INDIAN BEND WASH 3 LEVEE SYSTEM
MARICOPA COUNTY, ARIZONA
NLD SYSTEM ID # 3805020007

PERIODIC INSPECTION REPORT NO. 1
GENERALIZED EXECUTIVE SUMMARY

FINAL SYSTEM RATING: MINIMALLY ACCEPTABLE
FINAL RATING DATE: AUGUST 28, 2015

LOCATION AND LEVEED AREA MAP

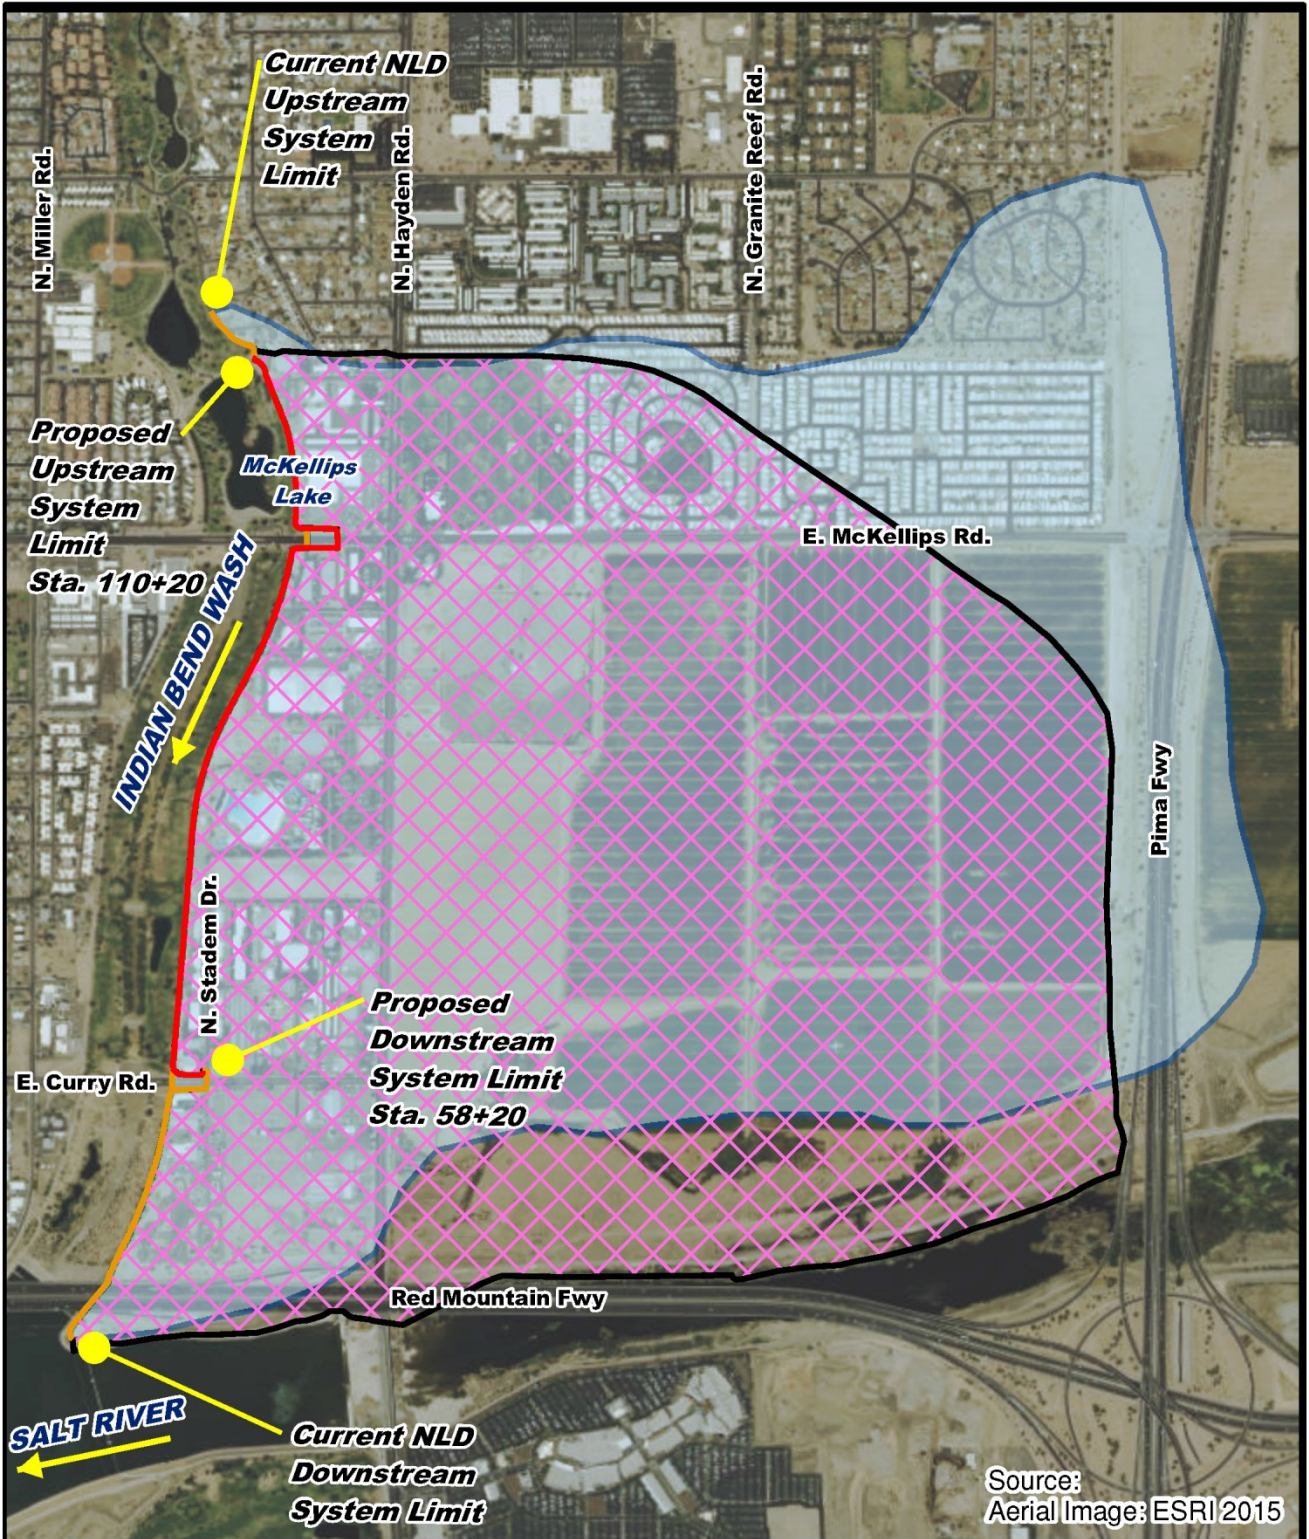
Figure 1 shows the IBW3 Levee System (NLD System ID #3805020007) and leveed area as depicted in the National Levee Database (NLD). Prior to this PI, USACE-SPL performed a field reconnaissance on December 3, 2013 to confirm or modify the information in the NLD. Items considered included the extent (limits) of the levee system and levee segments; the leveed area; and the number and locations of levee segments, gravity pipes, floodwalls, closure structures, and pump stations. The reconnaissance team eliminated channel reaches from the upstream and downstream ends of the levee system (a channel reach is a reach where the elevation of the ground on the landside is greater than or equal to the elevation of the levee system alignment (LSA) to a significant distance from the alignment). The reconnaissance team also recorded the number and locations of drop structures and groins, which are not included in the NLD. The reconnaissance team prepared a trip report (USACE-SPL, 2015) with the findings of this reconnaissance; a copy is included in Appendix X. The trip report is referred to herein as the Trip Report.

URS was asked to confirm the upstream and downstream limits proposed in the *Trip Report* or to recommend a modified limit and conduct the current PI on the basis of URS' recommendations. URS was not tasked with reviewing the full extent of the portions of levee proposed for deletion, only with observing whether the endpoints appeared reasonable based on the available information and observations in the field. Based on the PI observations and other information, URS agrees closely with the upstream and downstream limits of the levee system proposed in the *Trip Report*. The extent of the levee system and leveed area recommended by this PI is shown on Figure 1.
